CHAPTER 4.0

ERRATA

4.1 INTRODUCTION

FIGURE 2.0-13
PROPOSED GEN-TIE - AFFECTED APNS

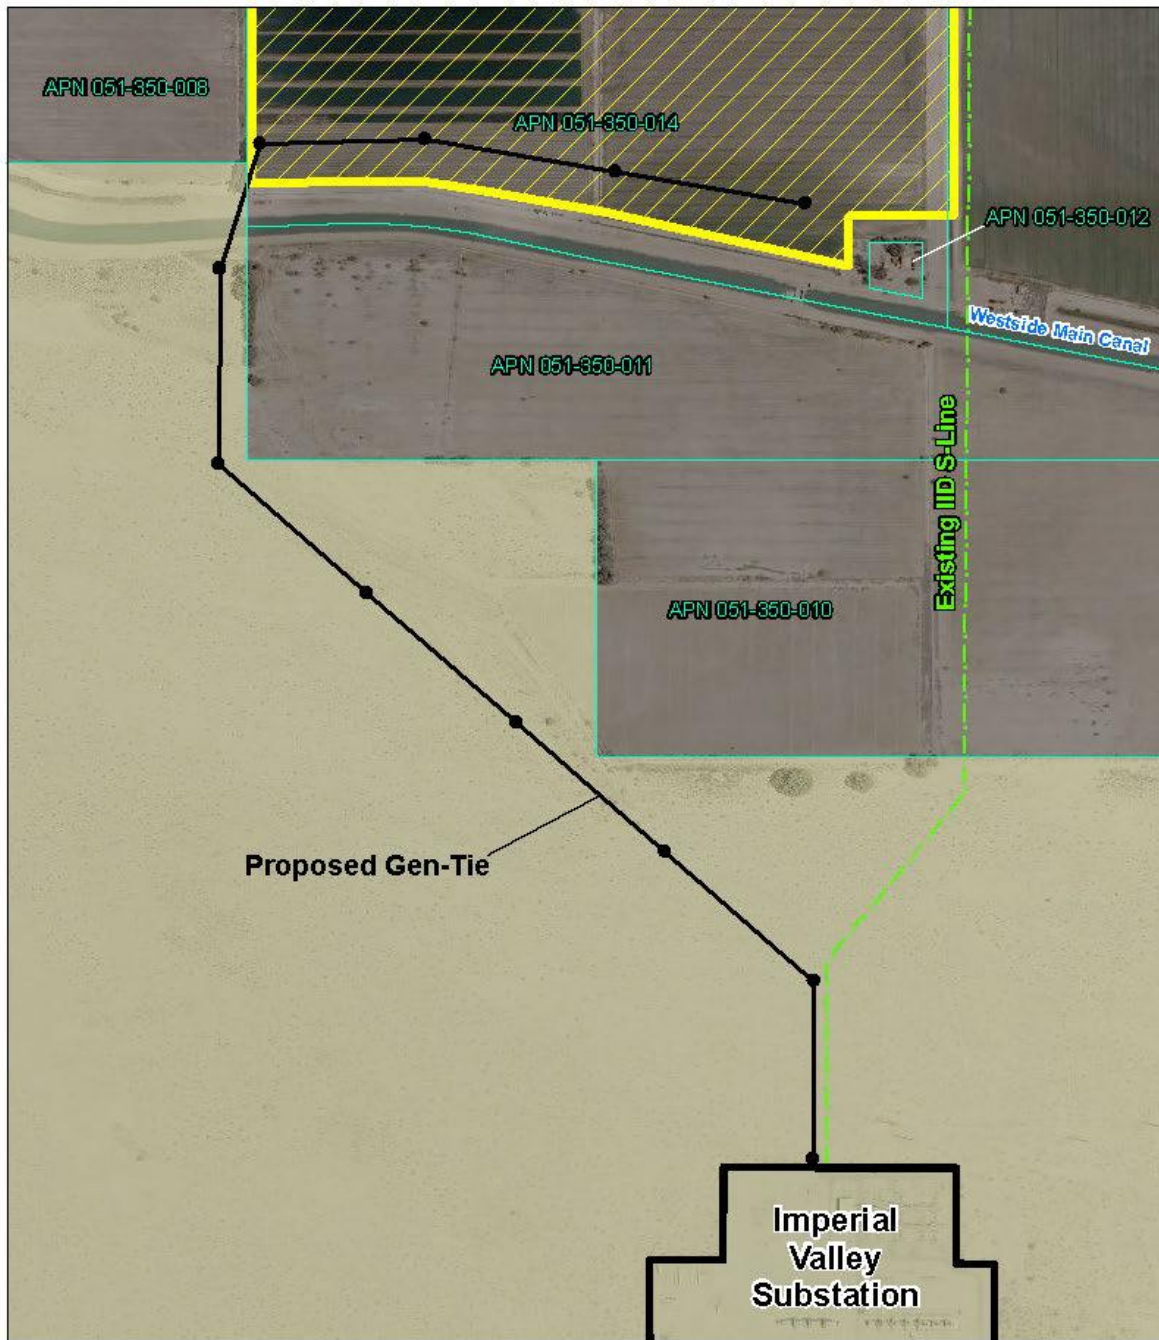
Figure 2.0-13 has been revised to reflect the affected parcels included in Table 2.0-2. The revised Figure appears on page 4.0-8 of this Errata.

FIGURE 6.0-4
 REDUCED SIZE SOLAR GENERATION FACILITY

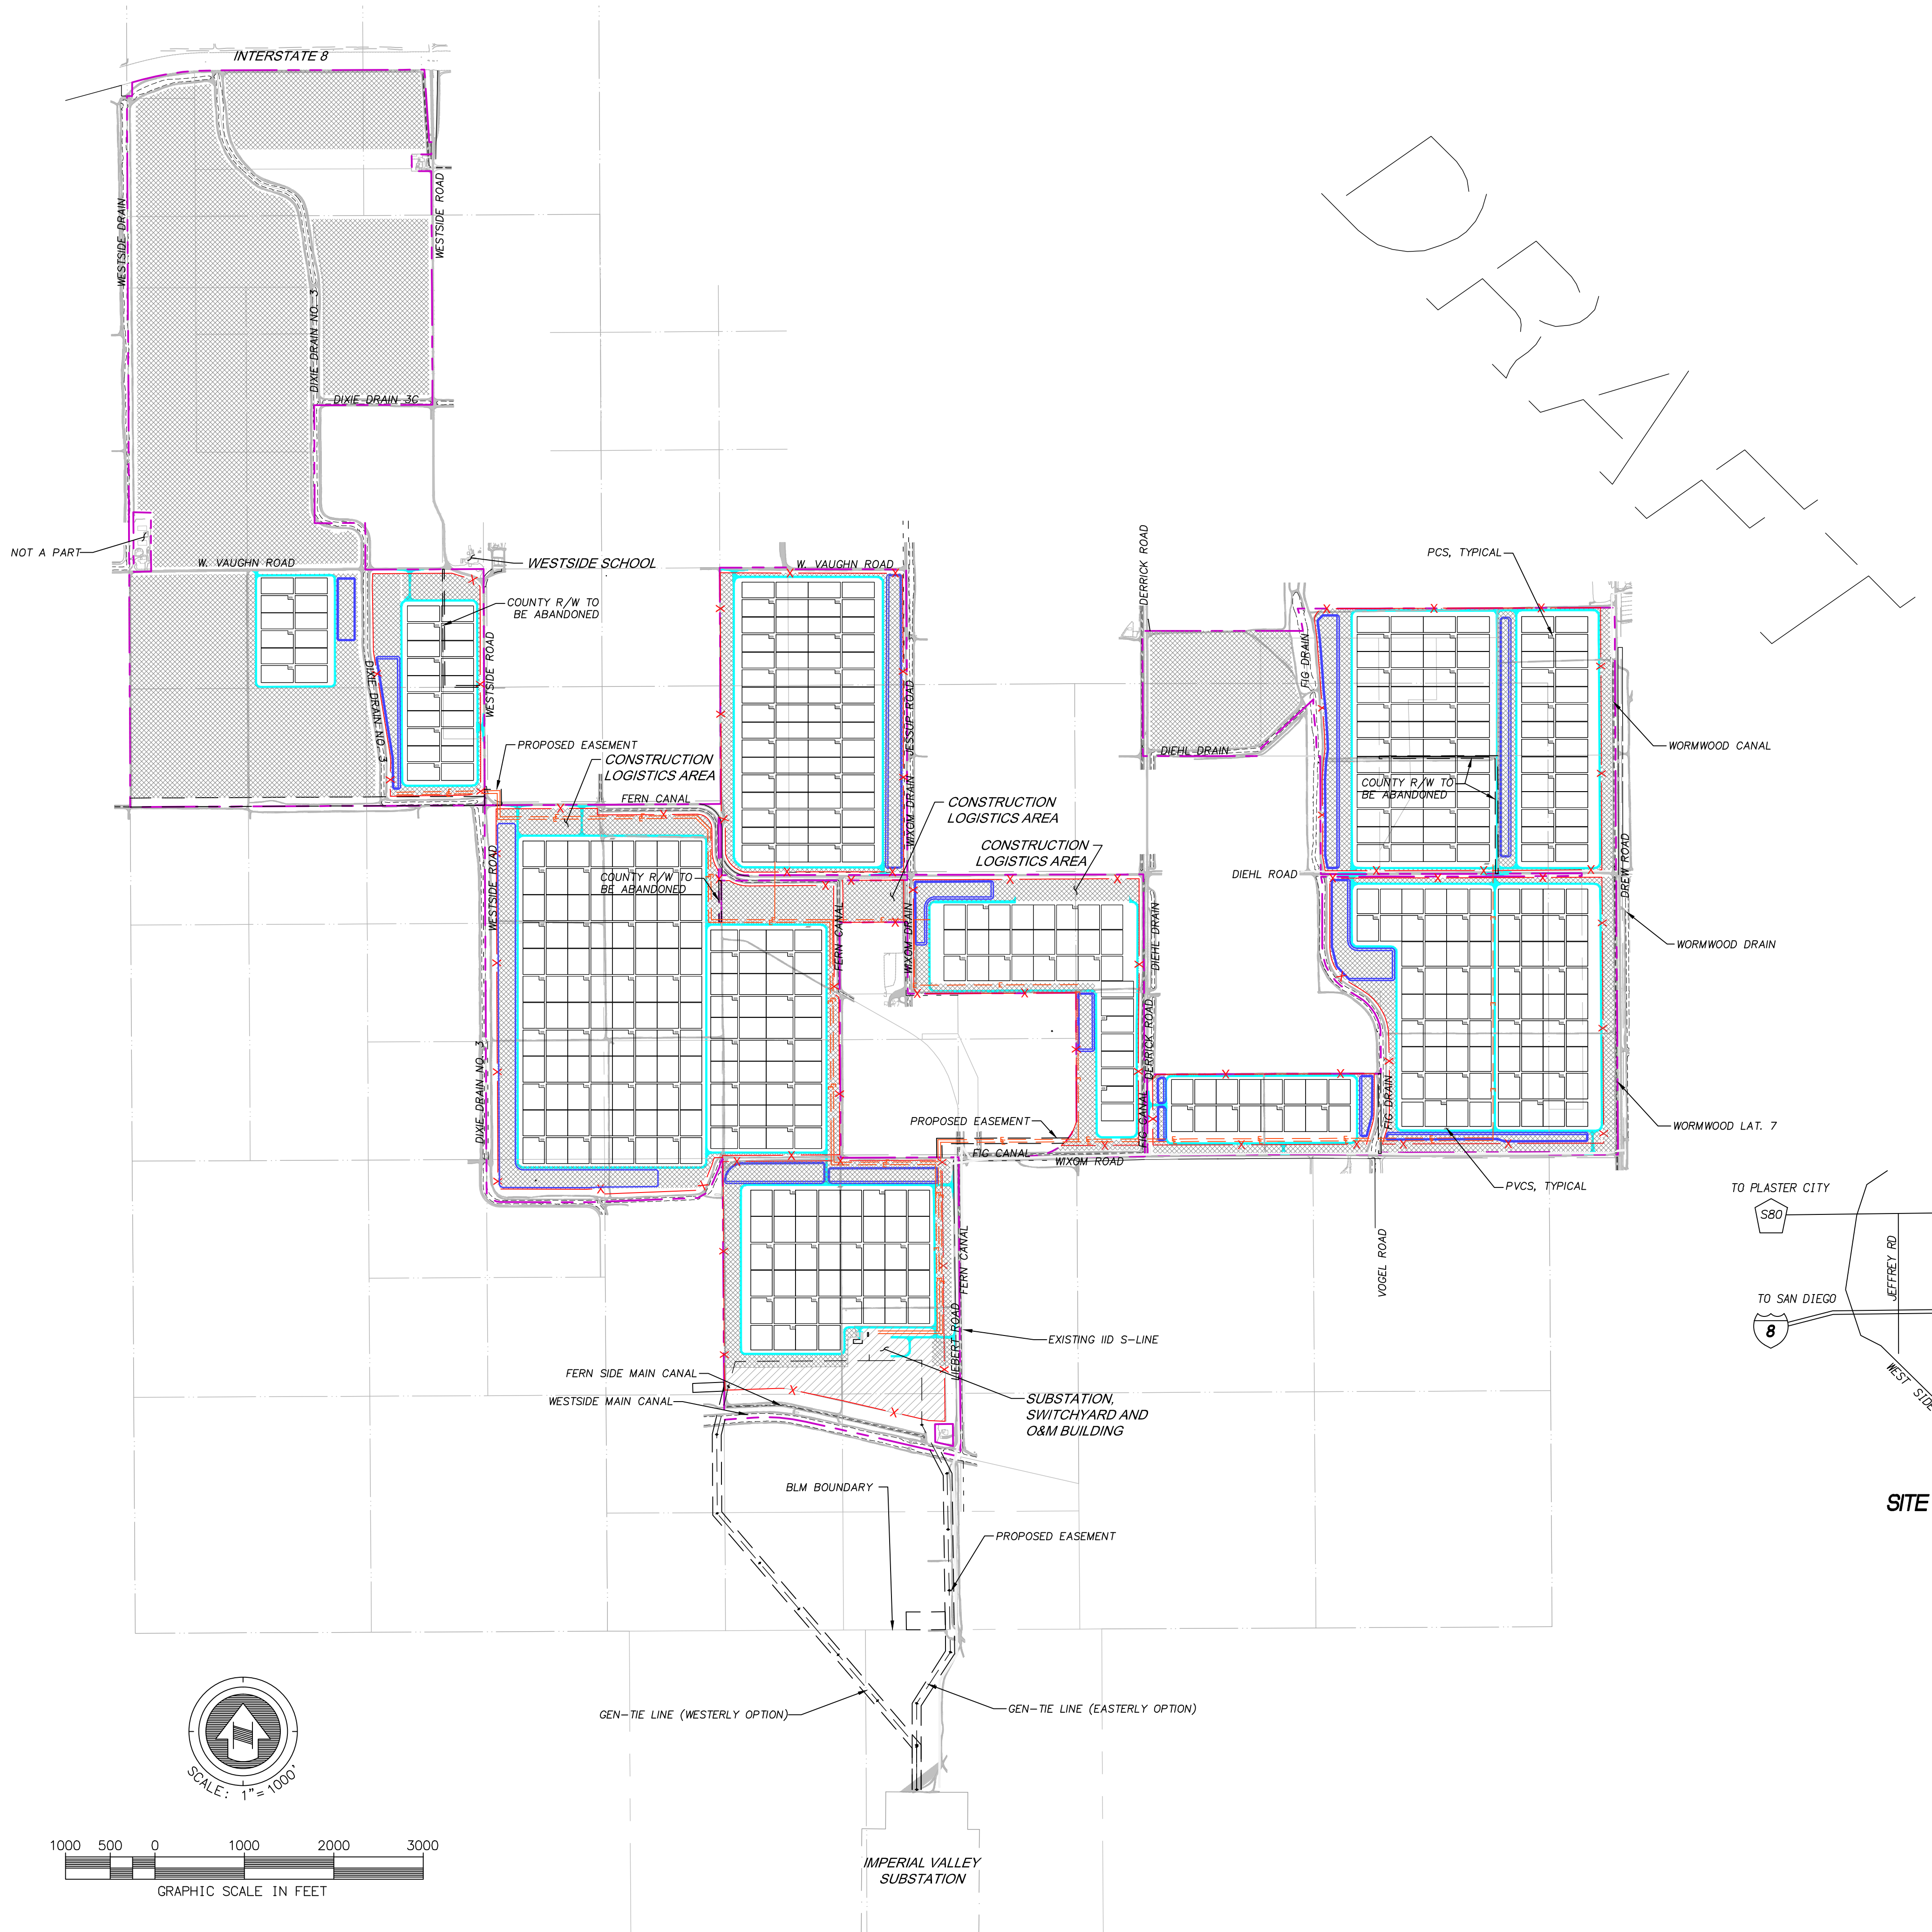
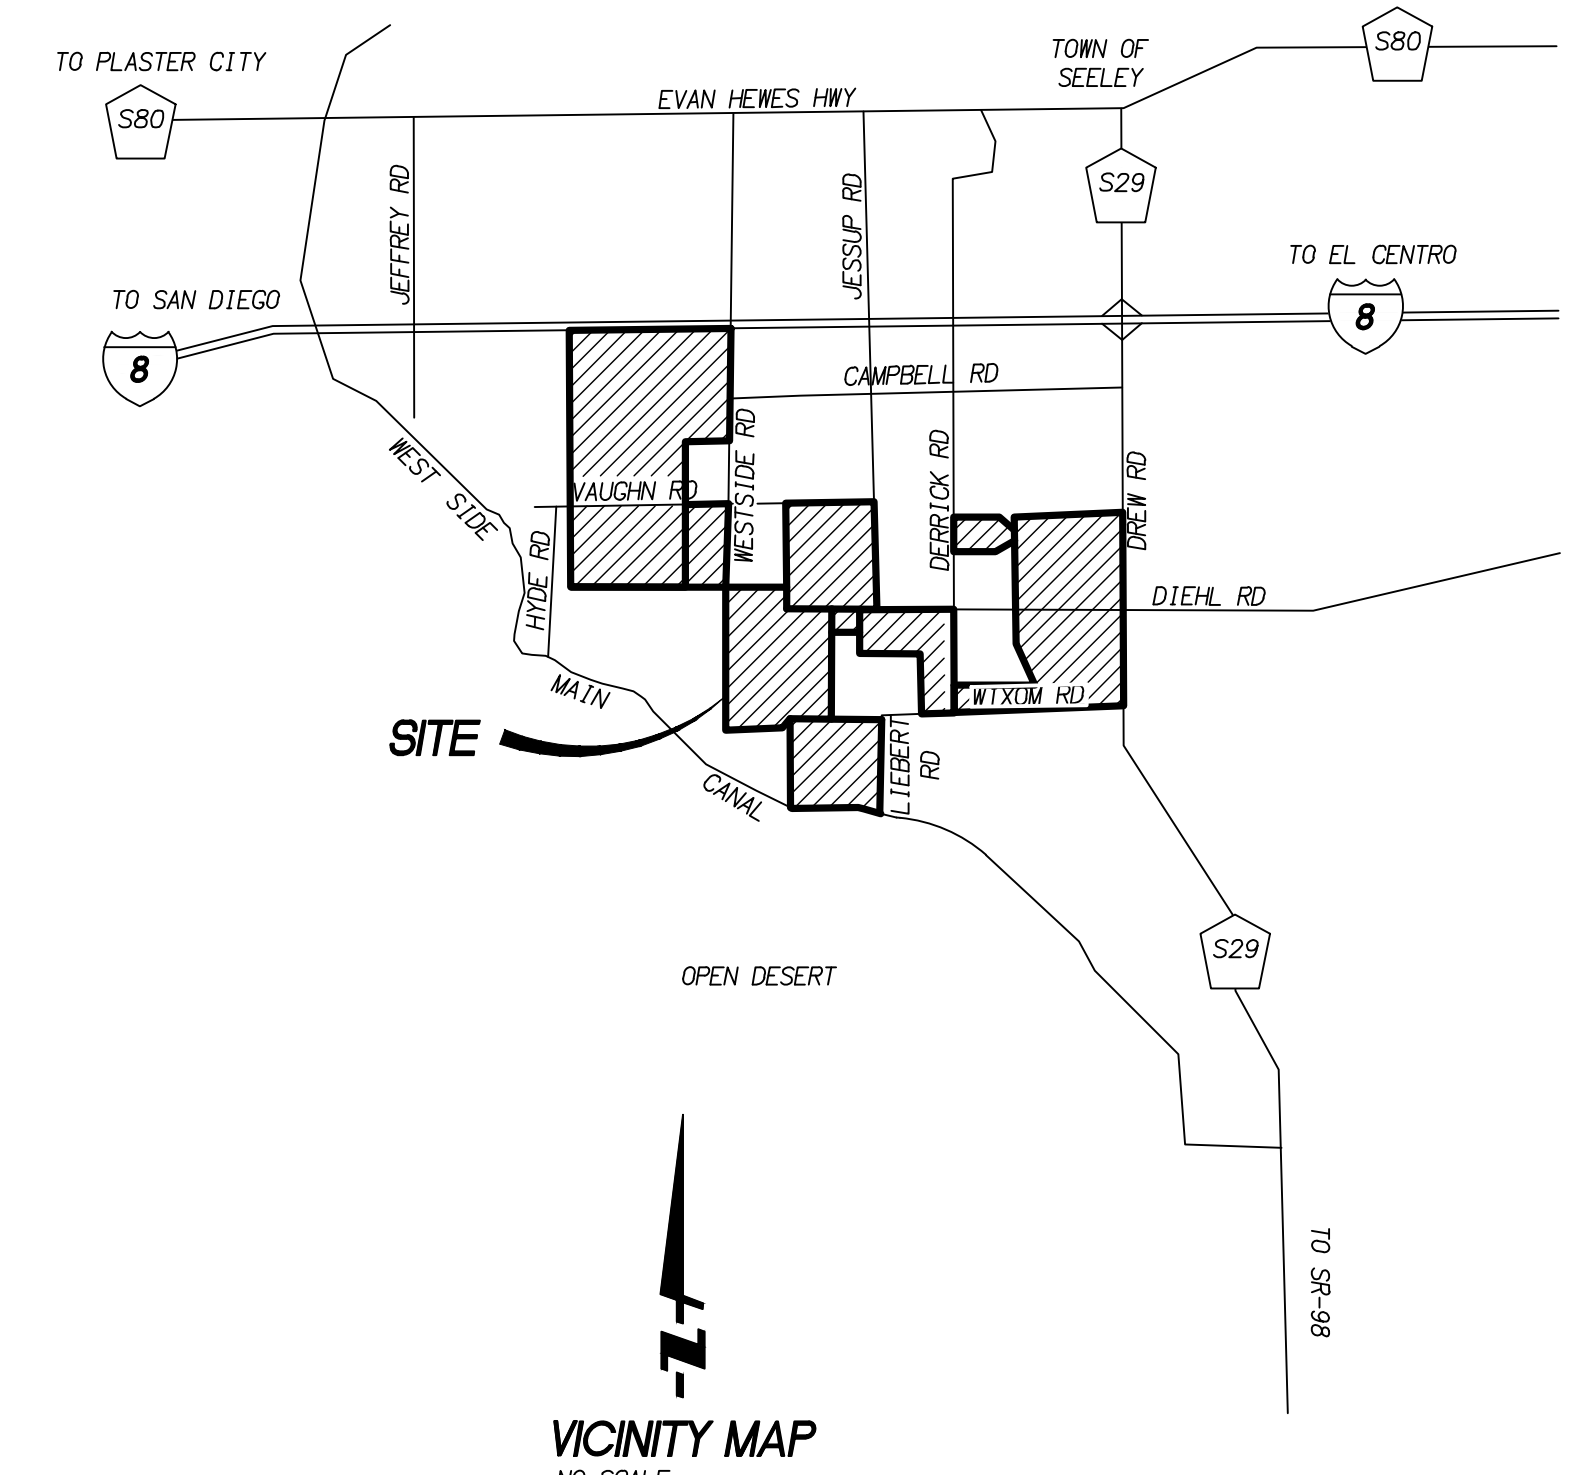
Commencing with the scoping period and through its direct outreach efforts, Campo Verde has received input from various stakeholders inquiring whether the company could reduce impacts from the solar generation facility to agricultural and environmental resources. In response to those requests and through the work of its design, engineering and supply chain teams, Campo Verde has developed a reduced size layout for the solar generation facility that reduces the amount of land necessary for the solar generation facility while maintaining the power output of the project. This alternative layout remains entirely within the scope and footprint of the proposed solar generation facility described in Chapter 2.0, but reduces the land area required for the facility and, as a result, reduces the impact to agricultural and environmental resources. The description of this “Reduced Size Solar Generation Facility Alternative” and its corresponding impacts to each resource area is set out in this Attachment. Campo Verde requests that the County include this alternative as a new alternative (Alternative 4) in the Final EIR, subject to the County’s independent review and assessment of the information set out below and any follow-up information which the County may request from Campo Verde. Figure 6.0-4 depicts the Reduced Size Solar Generation Facility Alternative.
